ADDENDUM NO. 1

**IMPROVEMENTS TO DEATS ROAD FROM GHRRR TO FM 1266
GALVESTON COUNTY, TEXAS**

Date: January 20, 2012

VDW&V Job Number: 24800-801-1-PAV

TYPICAL SECTIONS

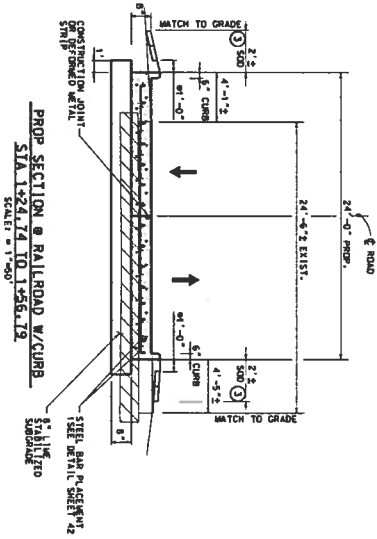
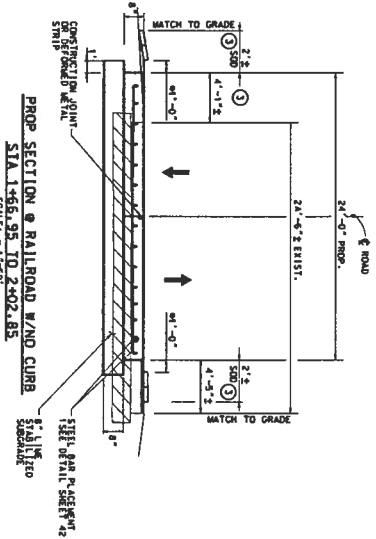
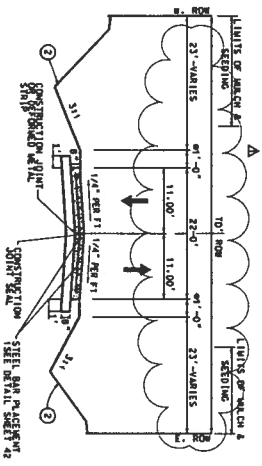
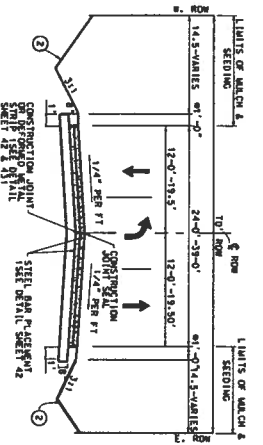
The proposed roadway width has been modified to be 22-ft wide continuously reinforced concrete pavement with a 1-ft shoulder. See attachment.
